***3 Volt Intel® Advanced Boot
Block Flash Memory
28F004/400/008/800/
016/160/320/640B3 (x8/x16)***

Specification Update

April 2002

Order Number: 297948-012

2. Invalid Read Durations for CE# High Pulse Width

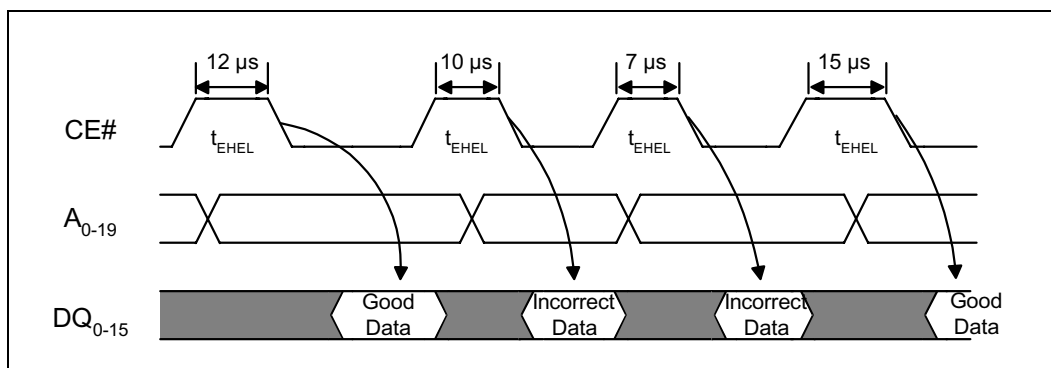
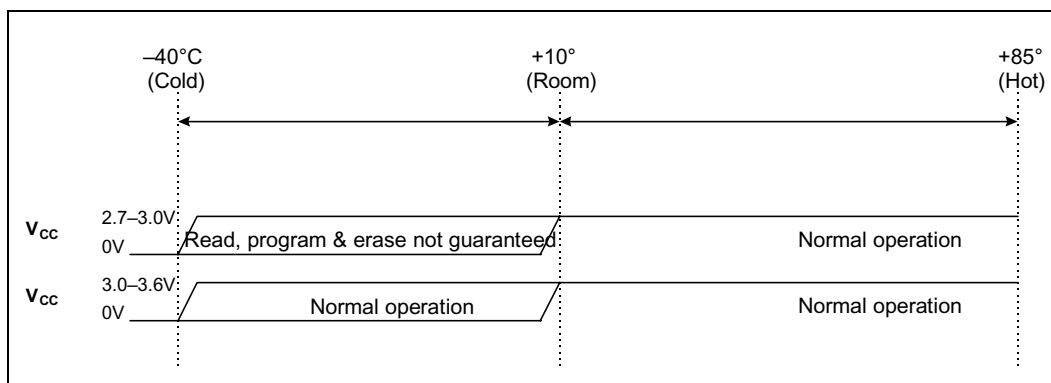
Problem: During consecutive read operations, CE# may be left low or toggled as desired. If CE# is toggled high (see diagram below) for 4 μ s–11 μ s between read operations, subsequent reads will return incorrect data.

Implication: If CE# is not toggled between consecutive reads, there is no impact. Any application that toggles CE# between read operations will be affected if the CE# high pulse width is within the nonfunctional range, i.e., 4 μ s $\leq$ t_{EHEL} $\leq$ 11 μ s.

Workaround: Either of the following actions will prevent this erratum:

1. Do not toggle CE# between consecutive read operations
2. Insure t_{EHEL} is less than 4 μ s or greater than 11 μ s

5. Maximum I_{CCD} Change

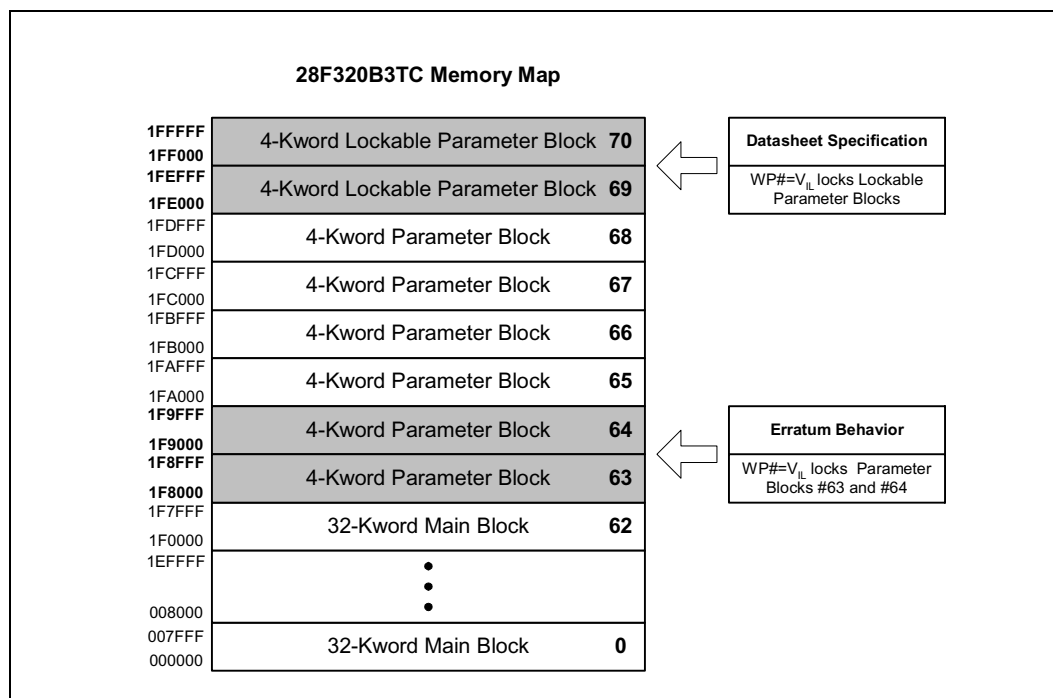
Problem: The maximum I_{CCD} increases from 20 μ A to 25 μ A. The following in the revised I_{CCD} specification:

Implication: The maximum I_{CCD} is specified under worst case conditions only ($V_{CC} = 3.6$ V, temperature = +85 °C). The typical I_{CCD} specification should be used to determine I_{CCD} current draw under typical conditions ($V_{CC} = 3.3$ V, temperature = +25 °C). The typical I_{CCD} specification has not changed.

7. 28F320B3xC Reset Failure

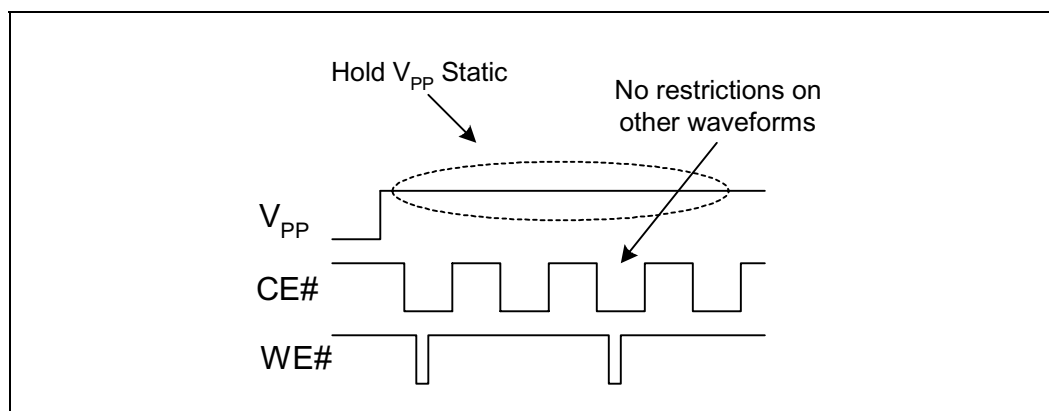
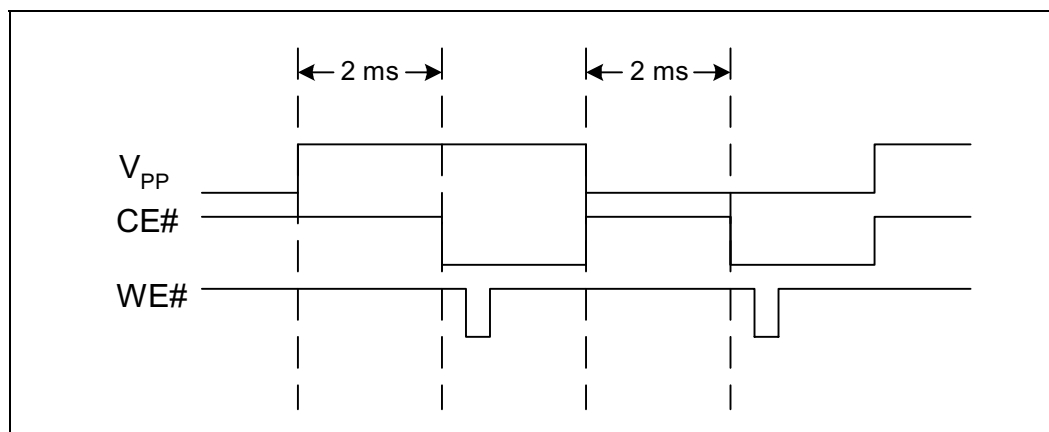
Problem: The 0.18 μ m 28F320B3xC devices can unintentionally reset under certain conditions where V_{PP} toggles.

Implication: When the reset occurs, any command being executed is interrupted and the flash switches to read array mode.

Workaround: There are four workarounds for this erratum:

1) Tie V_{PP} to V_{CC}

2) If the third and forth digits on the top side FPO mark (third line) are equal or greater than “23”, then V_{CC} may be set from 2.7 V to 3.3 V. V_{CC} must not exceed 3.3 V.

3) Set V_{PP} to a static high or static low level as shown here; and

4) Wait 2 ms after a V_{PP} transition to access the flash device as shown here.

Figure 1. Workaround Placement

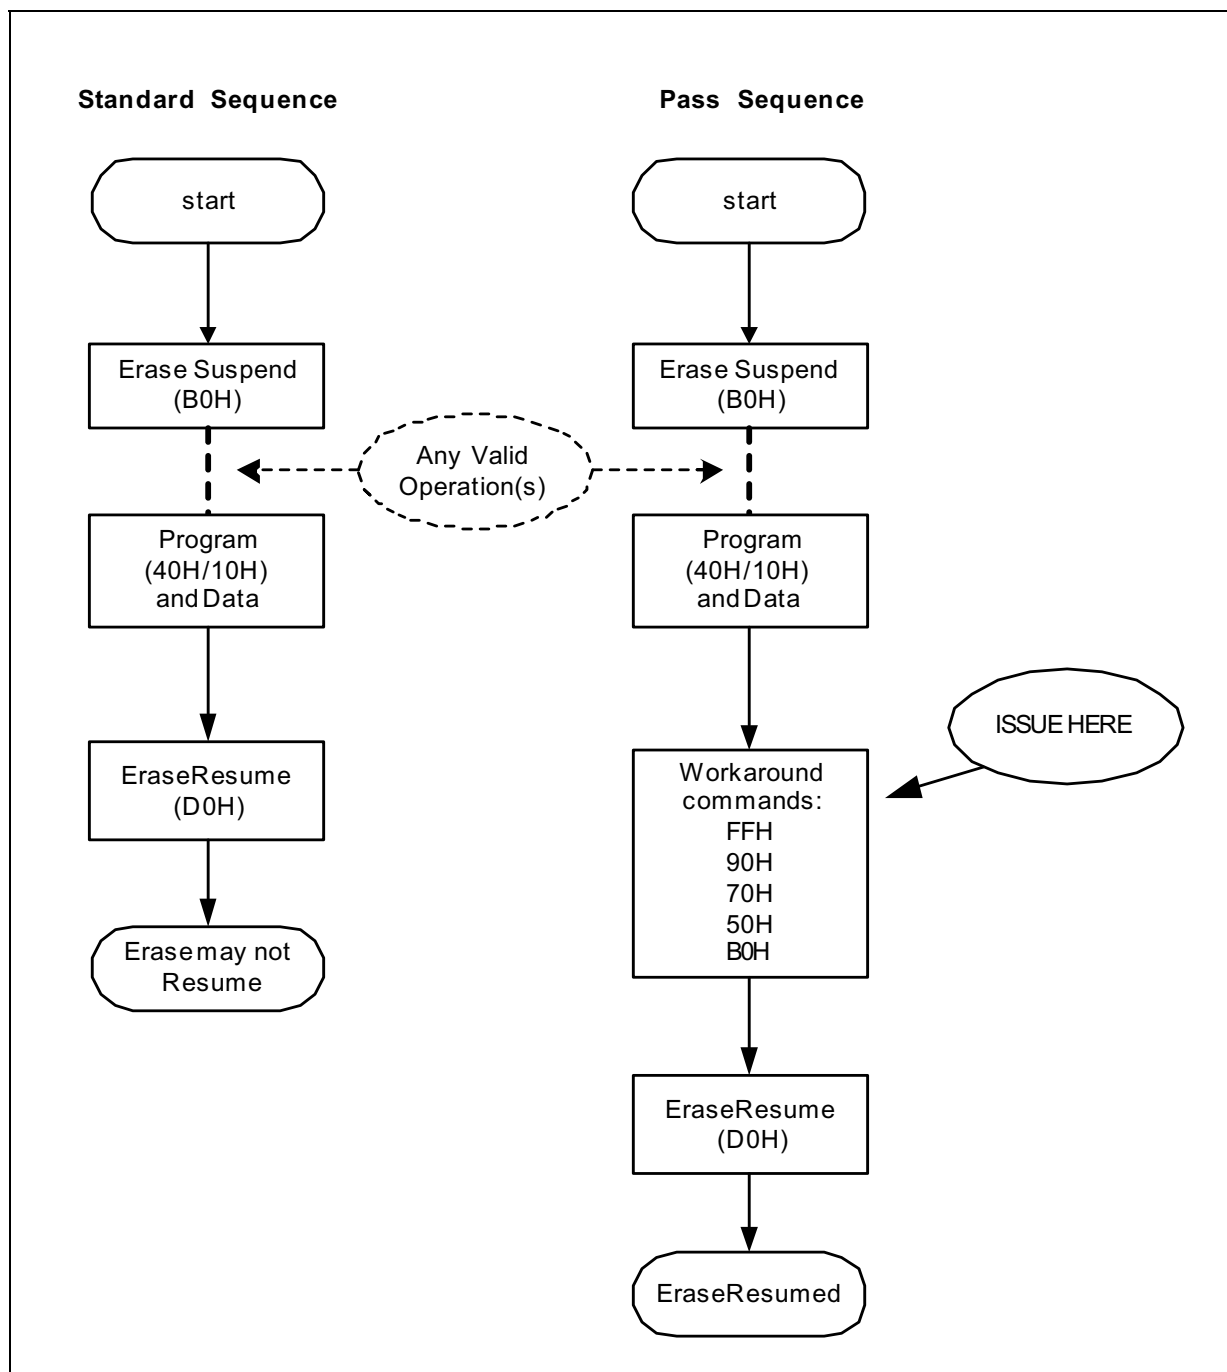
Problem: On the 0.18μm 28F160B3xC device, a design anomaly was discovered. During an Erase-Suspend operation, if the Program (40H/10H) sequence is executed, under limited conditions the proceeding Erase Resume command (D0H) may not actually resume the device. No customers have reported failures in product applications. Customers who use any version of FDI (Intel Flash Data Integrator) software will not see this issue. If the Read Array command is issued prior to the Erase Resume command, users will not see the issue (typical in XIP applications).

Implication: The Resume Command (D0H) may be ignored by the device and will not correctly resume. The device will appear to remain in suspend (via status register). After a reset of the flash device the status register will clear. This failure has been recreated in a lab environment only.

1. If FDI (Intel Flash Data Integrator) software is used, users will not see the issue.
2. During an Erase-Suspend (B0H), user must issue any of the following commands listed in Table-1 after issuing the Program (40H/10H) and data sequence but before issuing the Erase-Resume (D0H) command.
